Ministry
of Defence

ACP-2019-18

**GATEWAY DOCUMENTATION:
STAGE 2 DEVELOP & ASSESS**

**STEP 2A AIRSPACE CHANGE DESIGN OPTIONS
AND
DESIGN PRINCIPLE EVALUATION**

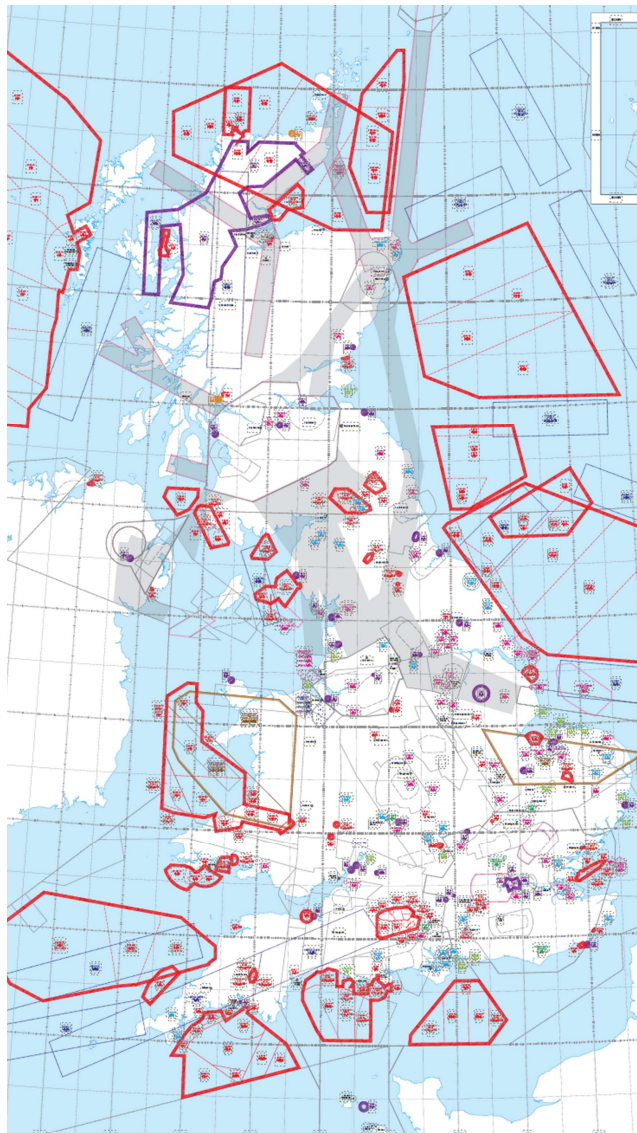
As a local resident, I am very familiar with the current E-3D flight profiles within the vicinity of Waddington and frequently view their flight track via commercially available apps (ADS-B-exchange, FR 24 etc..) which all show, and support my own observations, of HAND-FLOWN circuit patterns WELL WITHIN Waddington MATZ. If the largest dimension, aircraft in current RAF service is capable of being flown within the MATZ, why should a considerably smaller, fully autonomous aircraft need a greater area ?

I now find myself, along with an urban population of 130,200, or greater metro population estimated at 189,000 (according to the estimates from 2016) living within what will be an active DANGER AREA... the only such area within the UK located over a highly populated city and environs.

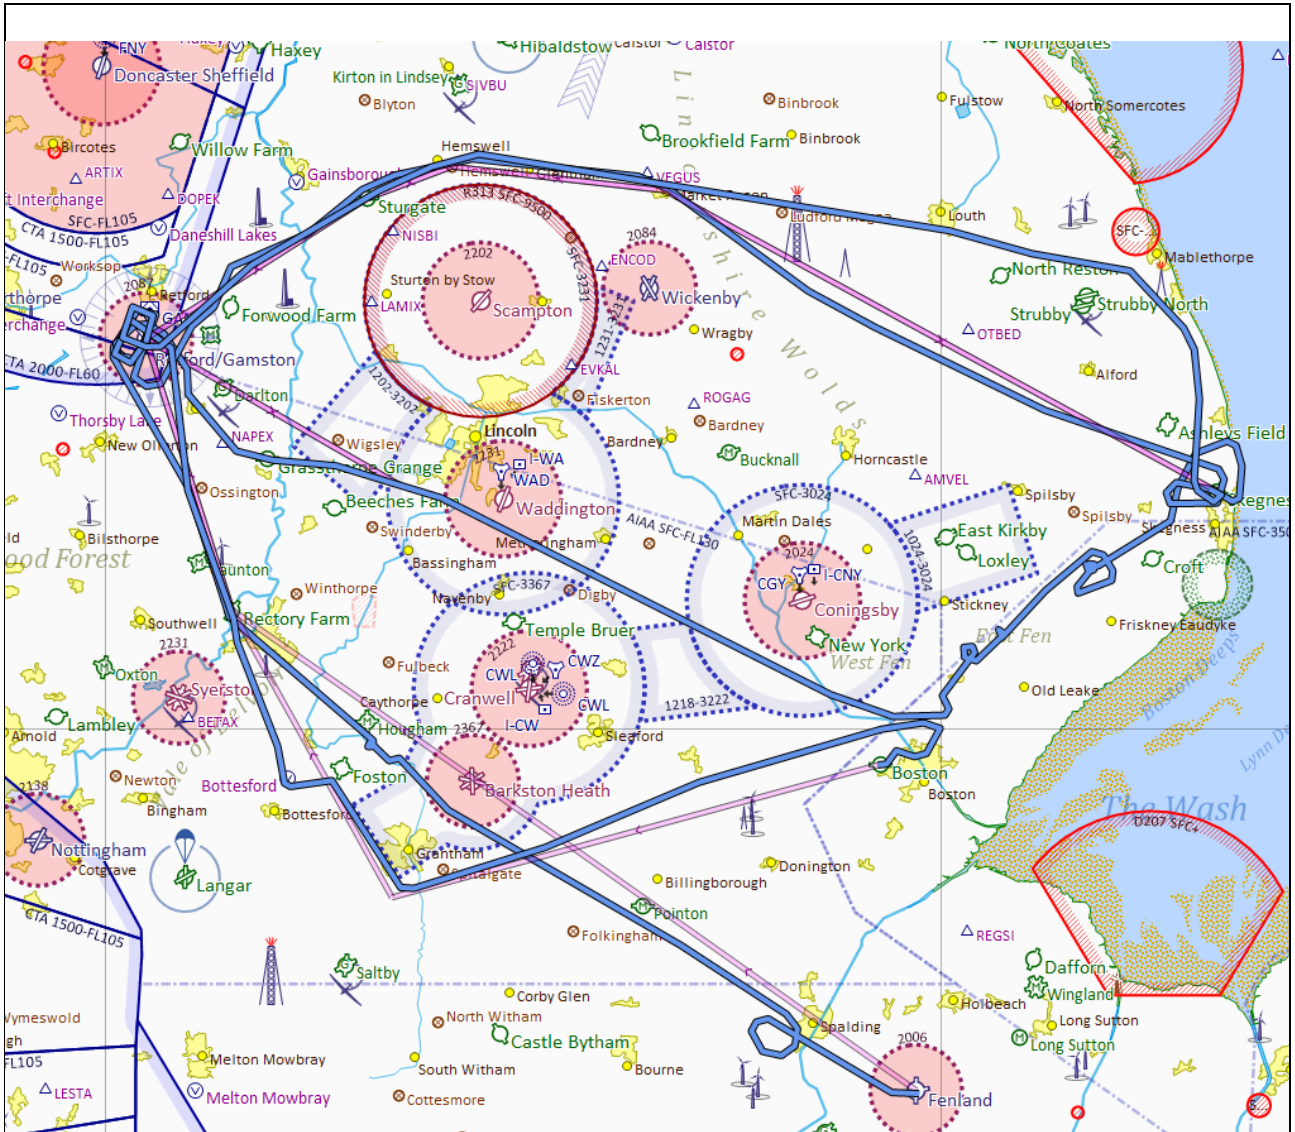
The map below shows typical examples of **my** detoured flights due to airspace design;

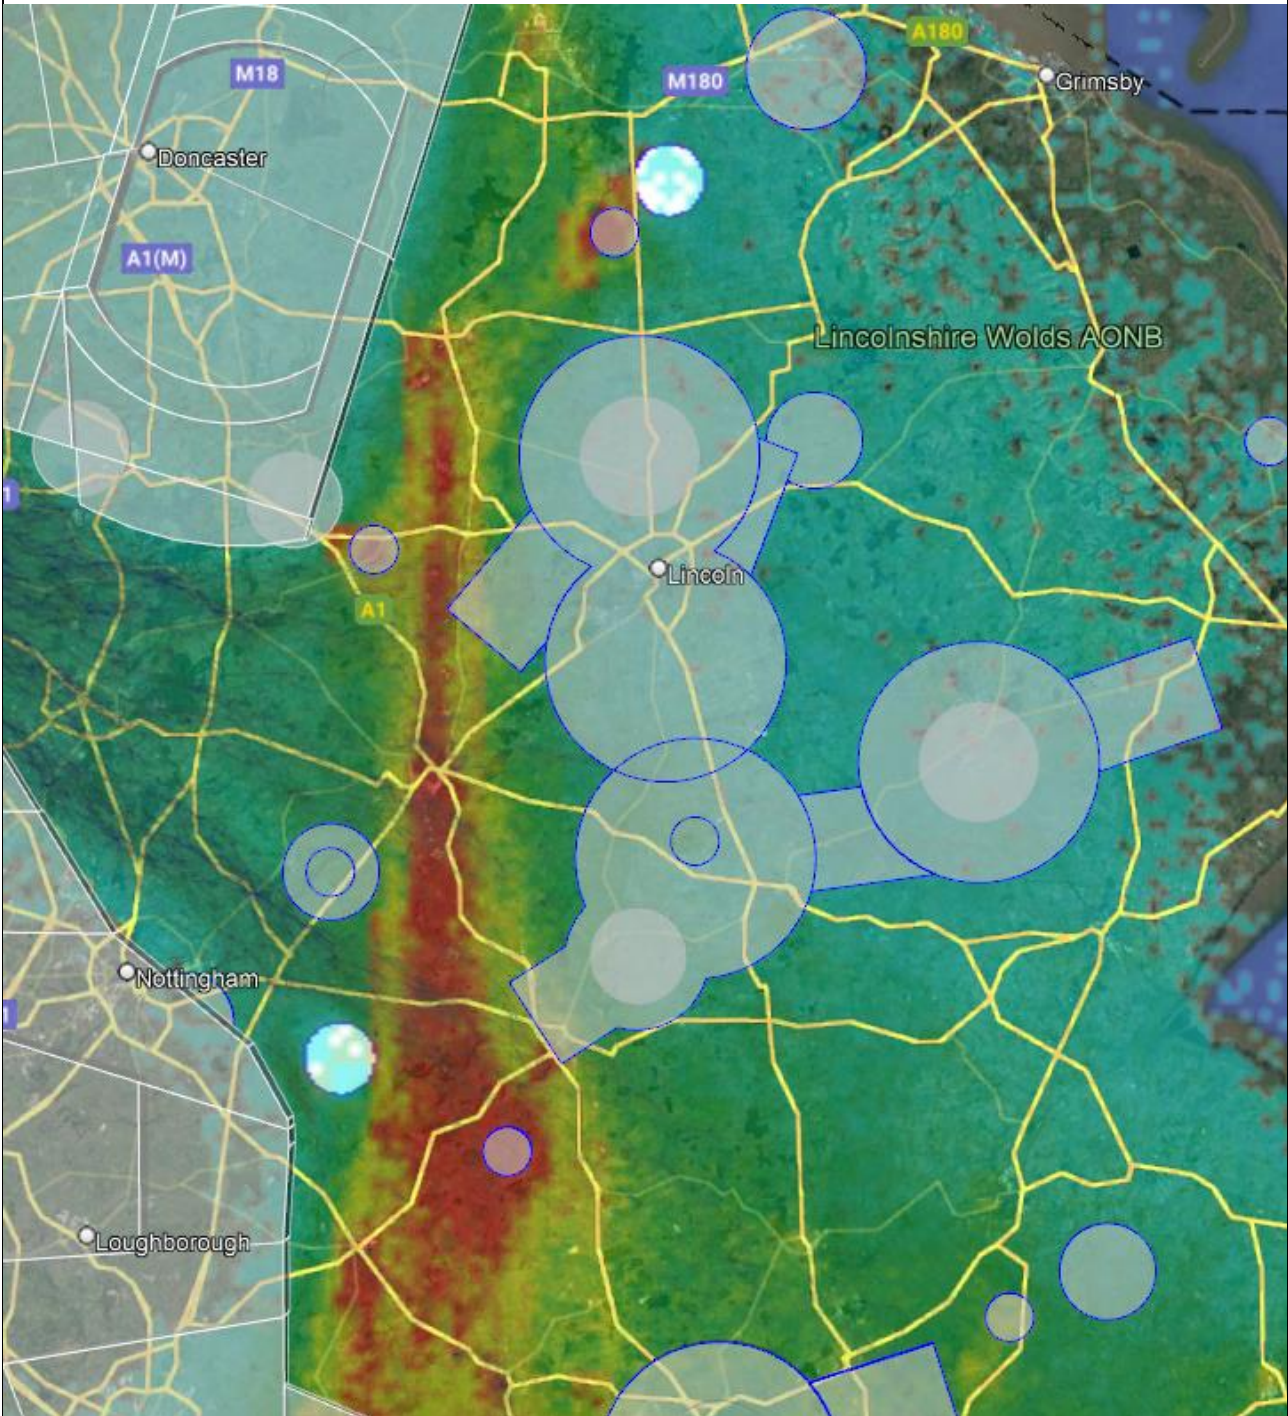
The map below shows a heatmap of aviation activity assembled by FASVIG. This represents just Gliding, Hand-gliding and Paragliding activity in 2018. The impact of airspace design can be easily seen on this map.

The removal of R313/Scampton Matz complex would have a beneficial effect on airspace safety by partially alleviating the 'Gainsborough' choke point.

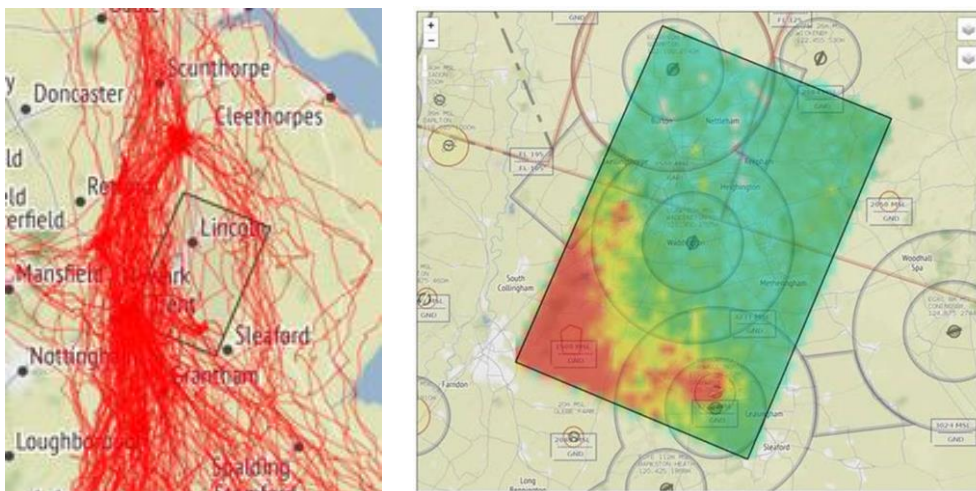
The following illustration is a FLARM trace heat map of gliding activity from two recent summer seasons. The hotspot around RAF Cranwell is primarily associated with weekend-only gliding activity. Most of the traffic highlighted in this heatmap is using an operating band of between 2000' and 5000' amsl.

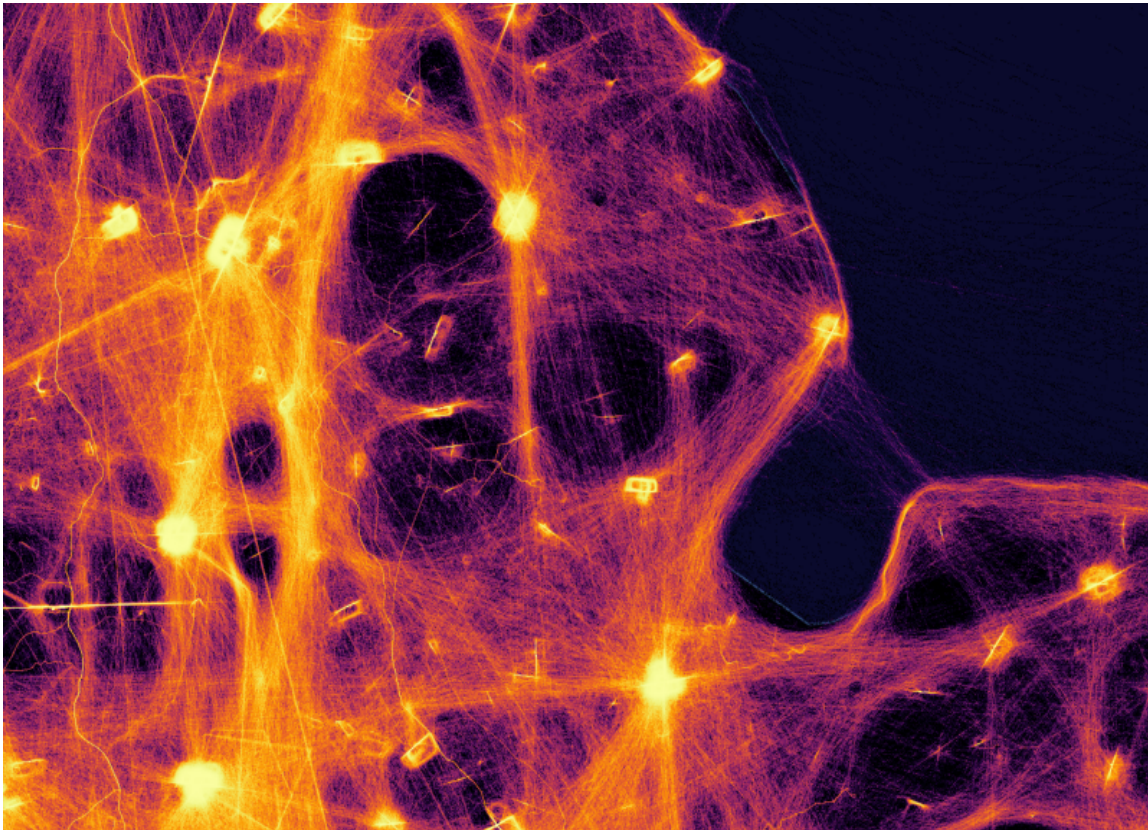
Yes it would impact operations from Rectory Farm.

The presence of restricted airspace will require re-routing of flights departing eastwards from our strip at Newark and negatively affect availability of our Low and Medium level training area whenever that restricted airspace is active. (Currently, even in the absence of ATC, we have the option to overfly Waddington MATZ is a preferred routing east from Newark to avoid R313 and also remain clear of gliding activity at Cranwell North). FASVIG/Skydemon have produced 'heatmaps' demonstrating the effect on concentrating traffic due to airspace design. (I also attached a Skydemon heatmap of traffic in the Caranwell area – showing traffic from April 2020).
